CONTRACT CHANGE ORDER NO. 02

PROJECT NAME: MAPLE STREET STORM DRAIN & ALLEY REHABILITATION

City's Project No.: PWP-00116

Description: Install 460 LF of 6" SS & 10 EA SS laterals on Alley S300K. Add contract time for the extra work and the anticipated long lead time due to material shortage delays.

Change Order #2 Request - Add Sanitary Sewer System on Alley S300K
This extra work will be paid for at the Contract bid unit prices for 6" plastic pipe and ss cleanout.

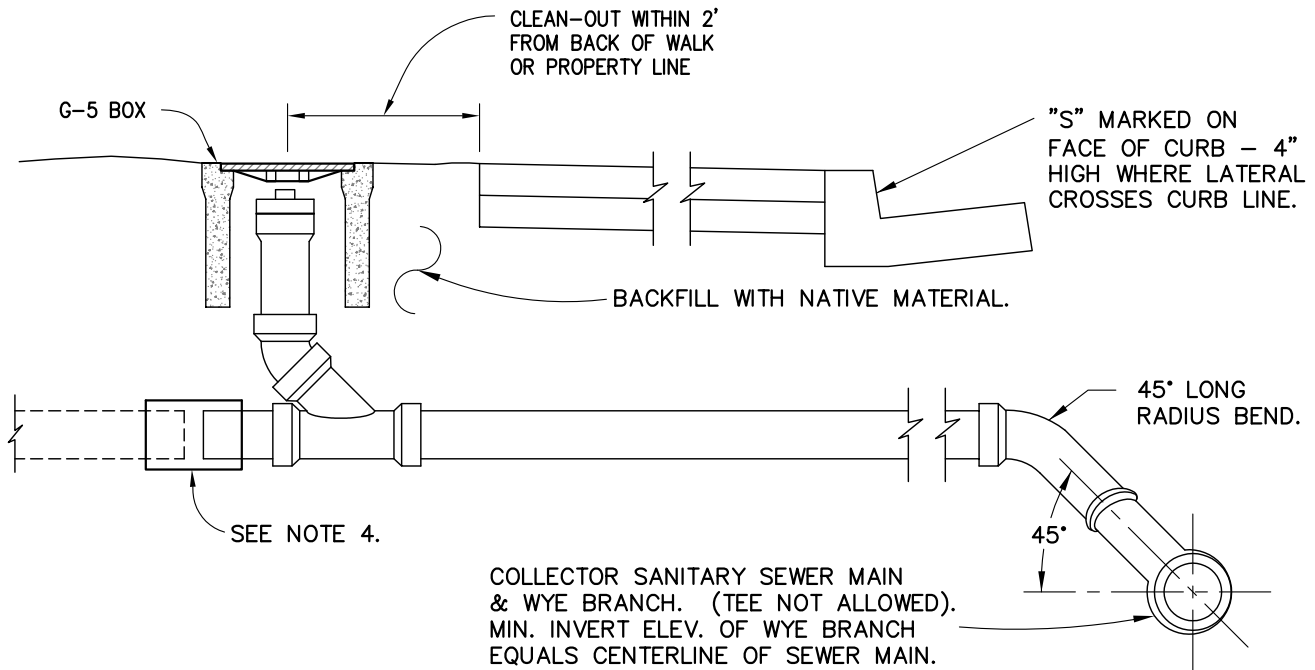
Purpose of Change Order: To eliminate a utility conflict and bring the sanitary sewer system on Alley S300K up to current City standards before paving.
